S10296

Optiview Panel LED Display

OPTIVIEW PANEL LED DISPLAY

LD19047

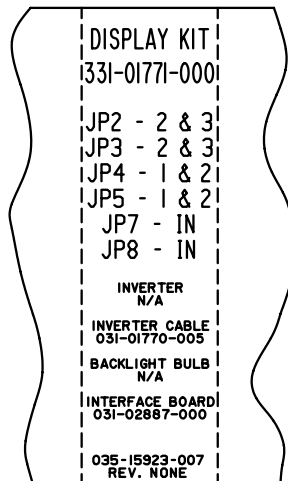
Starting around July of 2014, Optiview Panels and Service Replacement Kits (331-01771-000) started shipping with displays that use an LED for backlighting rather than the fluorescent display. The new LED backlit display is a Sharp LQ104VIDG81. The new LED backlight display does not need an inverter and uses a different ribbon cable. The display will not dim as the older one did to extend the fluorescent bulb life. The new display requires the following jumper settings on the 02430 microboard. JP4 is the only one that needs to be changed if you are updating from a Sharp LQ104VIDG61. This jumper controls the voltage that is applied for the backlight enable.

Set the 2430 microboard jumpers as follows:

035-15923-007

(FOR SHARP LQ104VIDG81 DISPLAY)
